NUCLEAR REGULATORY COMMISSION

In the Matter of: ADVISORY COMMITTEE ON REACTOR SAFEGUARDS
268TH GENERAL MEETING

DATE: August 12, 1982 PAGES: 1 - 258
AT: Washington, D. C.

13 (5) Proposed ACRS reports to NRC regarding
14 Grand Gulf and Ginna Nuclear Power Plants

Figure 3B-73. Loads at HCU Floor Elevation Due to Pool-Swell Froth Impact and Two-Phase Flow

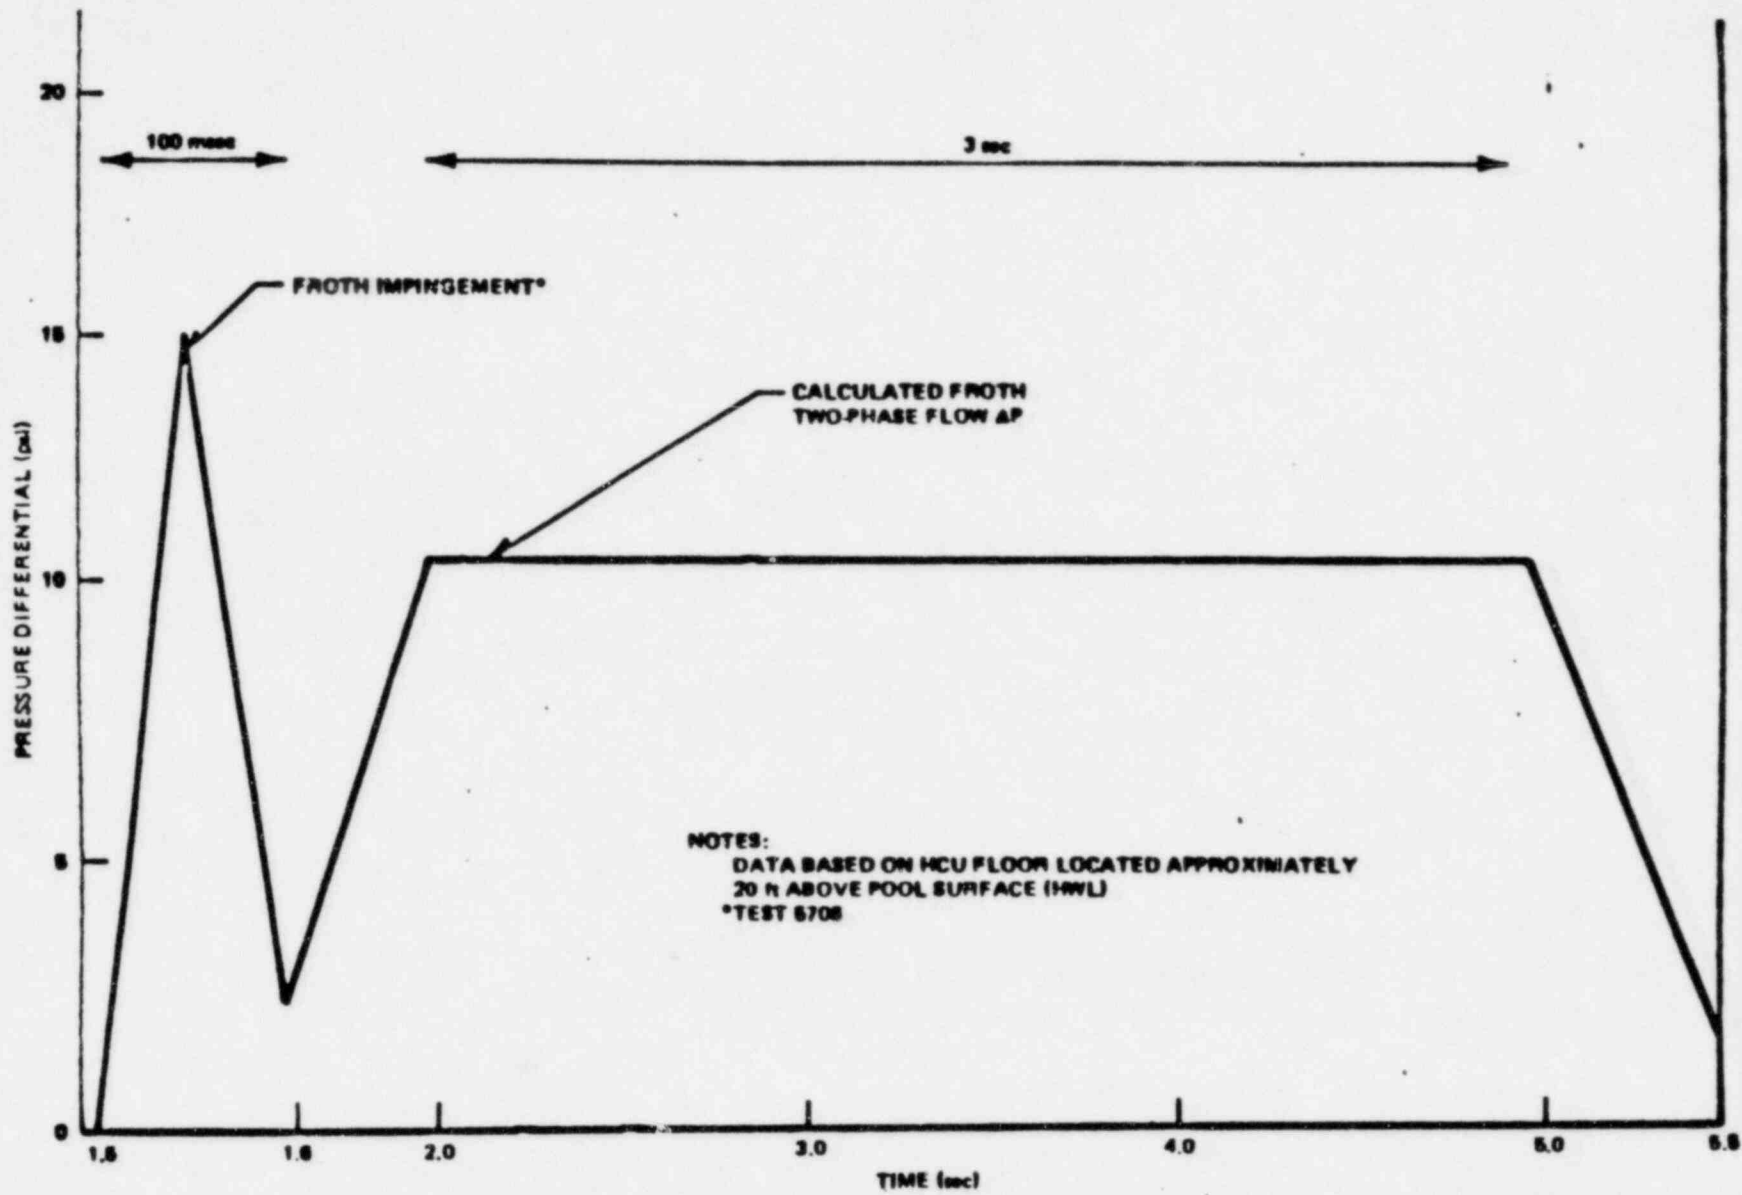
IN A MEETING ON DECEMBER 16, 1982, MP&L WAS REQUESTED TO EVALUATE THE EFFECT ON THE HCU FLOOR'S STRUCTURAL CAPABILITY OF THE NRC BEST-ESTIMATE METHODOLOGY FOR FROTH IMPACT LOADS.

- . FROTH IMPACT LOADS ARE VARIABLE.
 - DECREASE LINEARLY WITH INCREASING HEIGHT OF THE IMPACTED SURFACE ABOVE THE SUPPRESSION POOL.
 - DEVELOPED BY NRC CONSULTANT G. MAISE.
 - 3 PSI CONSERVATISM ADDED TO NRC REQUEST.
- . FROTH IMPACT DURATION VARIES BETWEEN 20 AND 220 MSEC.
- . FROTH IMPACT PRESSURE VARIES FROM 14.5 PSI TO 19 PSI.
- . FROTH DRAG LOAD IS 11 PSI FOR SOLID FLOOR AREAS (CONCRETE) AND 5.5 PSI FOR GRATING.
- . EVALUATION INDICATES THAT THE GRAND GULF HCU FLOOR IS CAPABLE OF WITHSTANDING THE REVISED FROTH IMPACT LOADS.
